The following changes in the tender documents are effective immediately. This addendum will form part of the Contract documents.

Project No. R.0171363.001

Addendum #002

Tender A – Pleasant Camp Port of Entry

1 SITE SERVICES BUILDING PLUMBING & FIRE PROTECTION PLAN
 M101 SCALE: 1:50

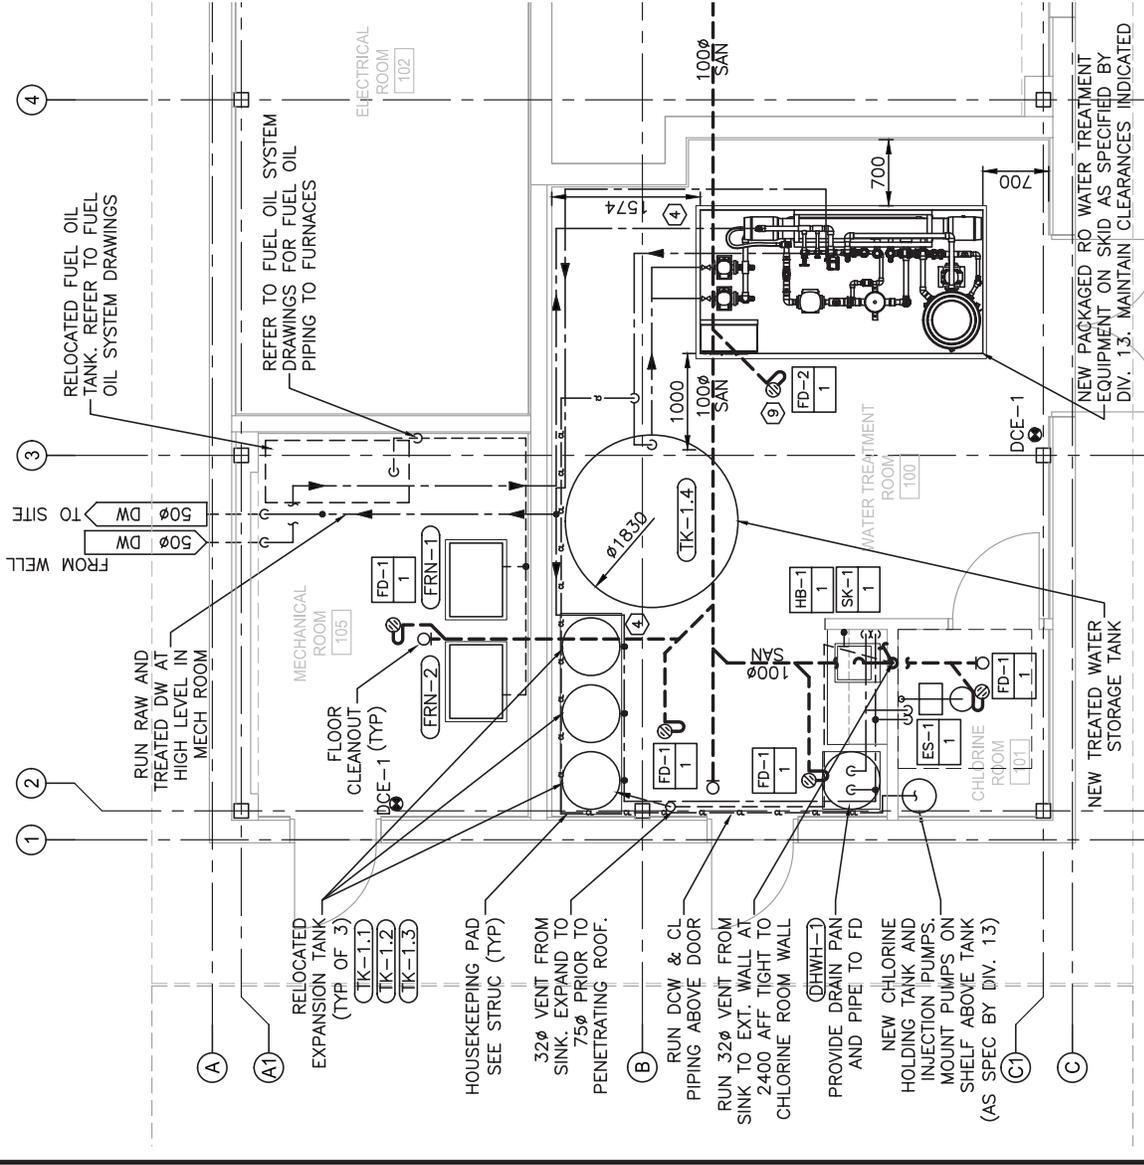
1. Drawing M101, plan 1: Revise layout to accommodate RO treatment system skid and new tank TK-1.4 as shown on attached sketch SKM-001 including:
 - a. Delete TK-1.4 and replace with new treated water storage tank TK-1.4 bolted to the floor

- b. Provide new RO Water Treatment Skid per specifications included herein
 - c. Delete TK-1.5 and TK-1.6 installation, turn over to owner instead. Delete associated housekeeping pad.

- d. Delete new 1 and 10 micron filters.
 - e. Replace TK-1.7 and CL-1 and CL-2 with chlorine tank and pumps included as part of the water treatment package per specifications.

- f. Relocate TK-1.1, 1.2, 1.3 to and provide associated housekeeping pad.
 - g. Relocate emergency shower and associated floor drain to chlorine room and leave wall clear for electrical panel (South side of East-West wall dividing Water Treatment Room and Chlorine Room)

- h. Relocate hose bib to sink side of wall and leave wall clear for electrical panel (South side of East-West wall dividing Water Treatment Room and Chlorine Room)

- i. Revise floor drain adjacent to RO Water Treatment Skid to FD-2 and coordinate location with Skid.
2. Drawing M102, schematic 6: Revise per attached sketch SKM-002.

KEYNOTES
 ① COORDINATE LOCATION OF FLOOR
 ② DRAIN WITH RO SKID.

6 WATER SERVICE SCHEMATIC — REVISED
SCALE: NTS

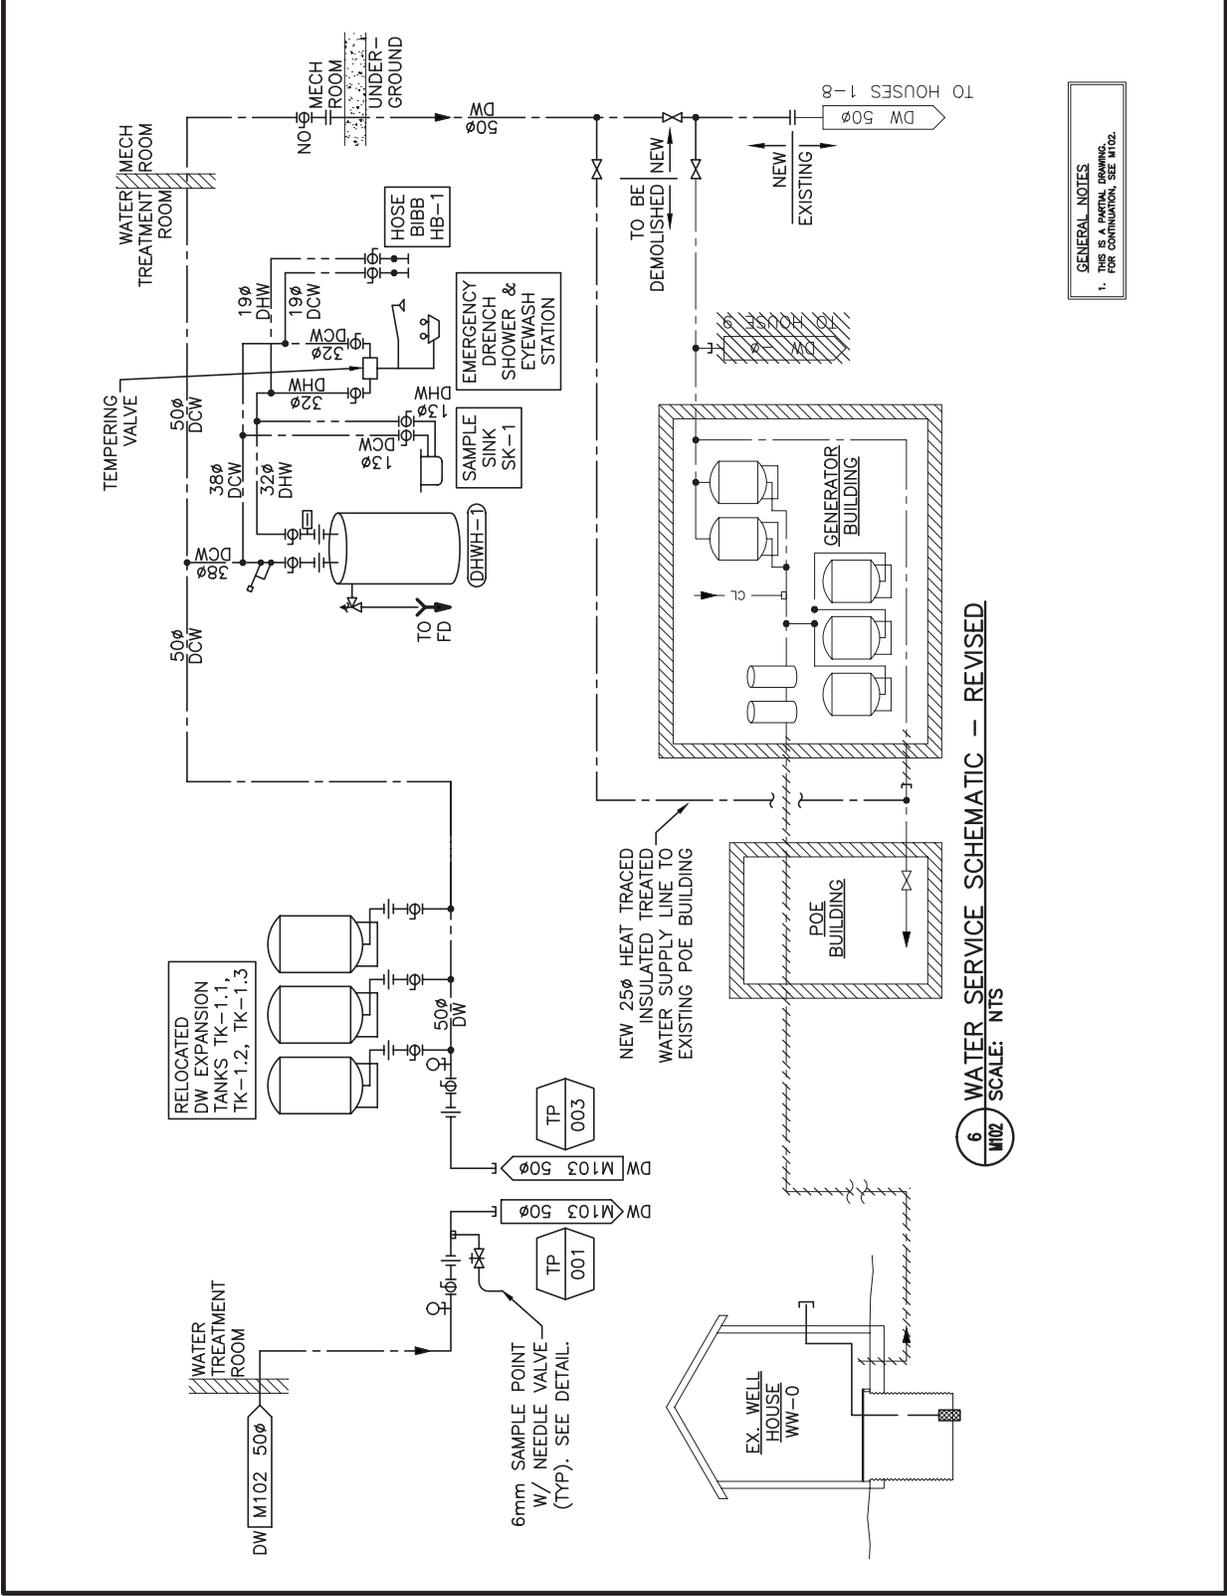
3. Drawing M102, schematic 6: Revise per attached sketch SKM-002.
4. Drawing M701, Plumbing Fixtures Schedule:
 - a. Add FD-2; Description = Funnel Floor Drain, San diameter = 100mm.
